RE: MODIFIED STRUCTURE PLAN. LOT 8016
BANNISTER MARRADONG ROAD.

On behalf of Barenco Pty Ltd and Stone Developments Pty Ltd, the owners of Lot 8016 Bannister Marradong Road and Lot 9501 River Road Boddington respectively, please find enclosed a modified structure plan for the above property.

Enc. Structure Plan Dwg No. T012/SP/Mod/01
Impact Urban Design Correspondence to Water Corporation dated 26 August 2008.
Water Corporation correspondence to Impact Urban Design dated 28 August 2008.
Shire of Boddington Land Capability Analysis

Appendix 1 Aerial Map Lot 8016 Holes dug numbered

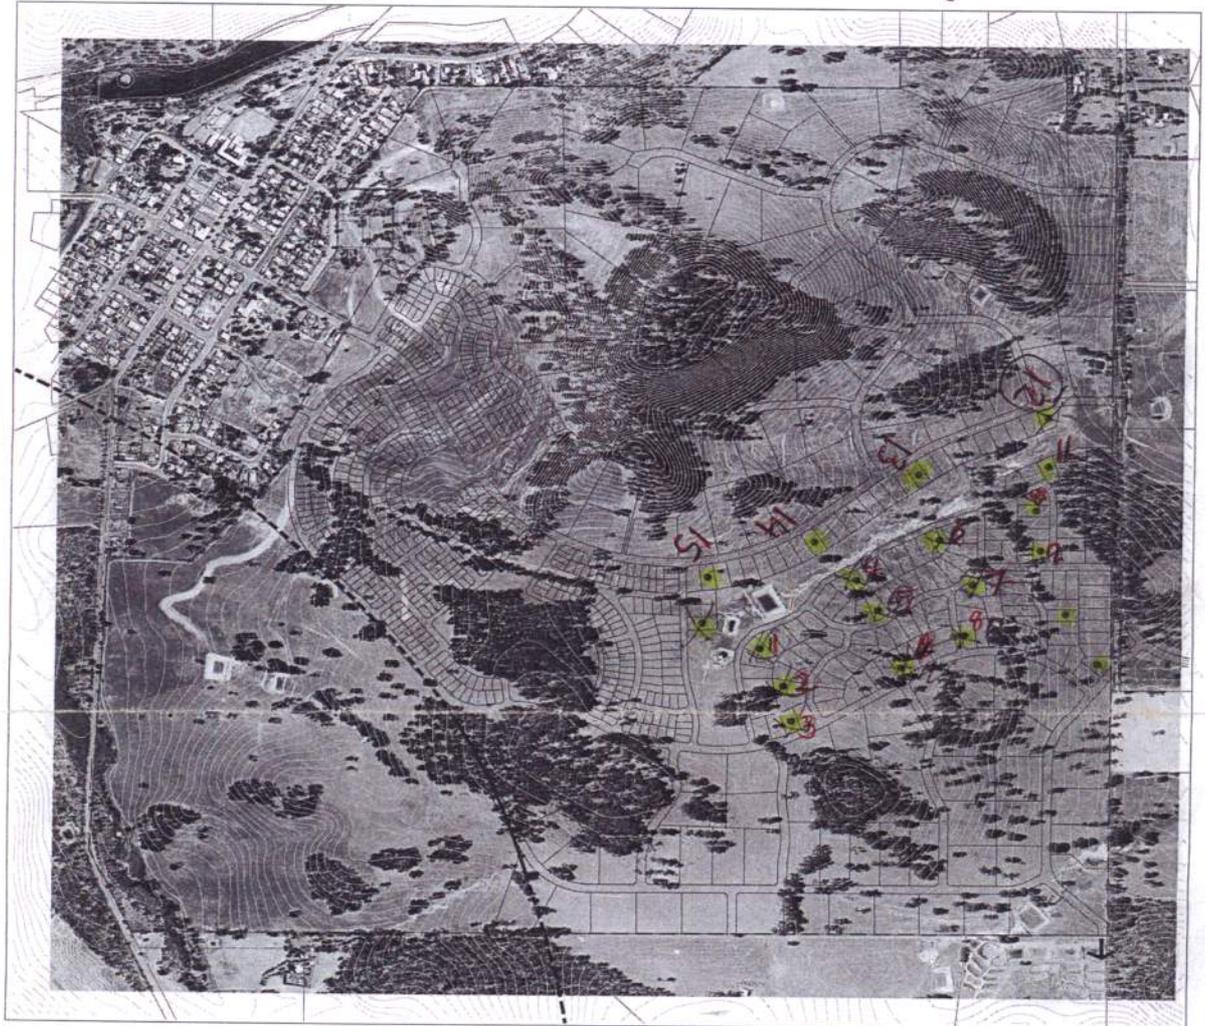
The purpose of the inspection was to ascertain the suitability of the site for effluent disposal purposes. To do so a number of test holes to a 1.5 metre depth were dug over the site in question. The location of the test pits are outlined in Appendix I attached to this report.

From my observation of the conditions on the site parts of the area concerned are suitable for conventional septic tank systems. The conditions imposed on the installation of conventional systems may vary over the site and would be investigated at the time of building once the location of the system is known.

The Lots proposed near the creek line would require an alternative waste water treatment unit to be installed to Health department requirements for wet blocks. These alternative waste water treatment units may include aerobic treatment units or the ecomax system. This condition would apply to the Lots immediately adjacent to the creek line. The conditions applied to use these units would depend on the location of the unit and the conditions of the individual site.
